C2032x MAIN FIRMWARE RELEASE NOTES

Uni-7 Series with PK-260B CPU Board

C2032x supersedes B0779x as the standard Uni-7 firmware for the revised PK-260B CPU board.

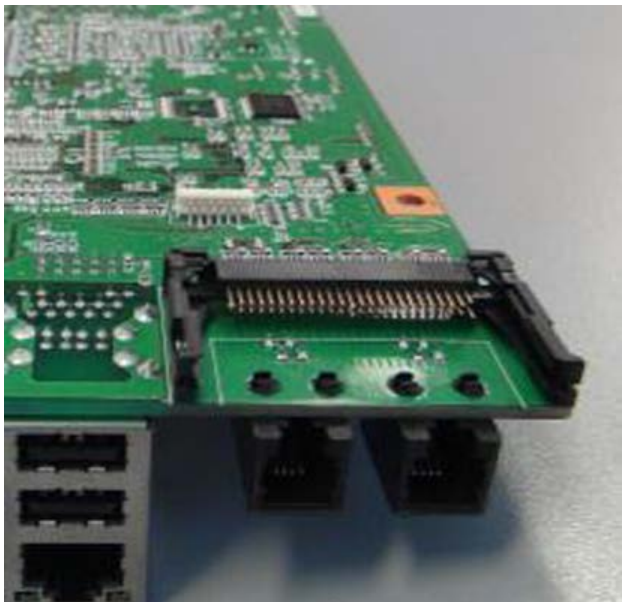
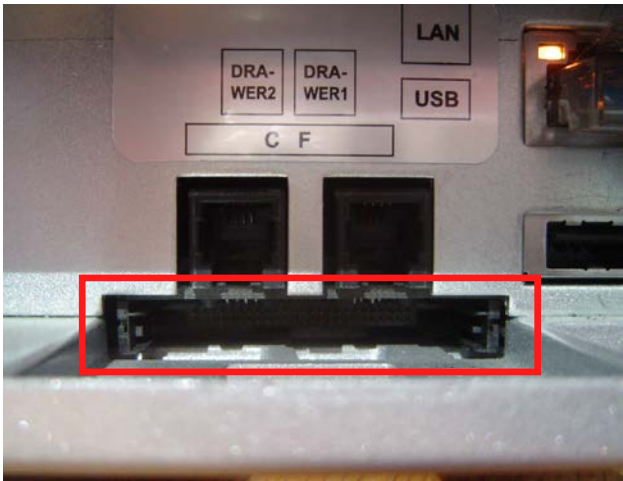
Firmware C2032x is designed for the revised CPU board PK-260B. **This firmware is not compatible with the previous CPU board PK-260A.** And previous firmware (B0674x, C1991x, etc.) is not compatible with the new PK-260B CPU board.

The two CPU board versions can be easily identified by the expansion memory card slot located on the left side of the Uni-7. See the images below.

C2032x PK-260B with SD Memory Card Slot

C1991x PK-260A with CF Memory Card Slot
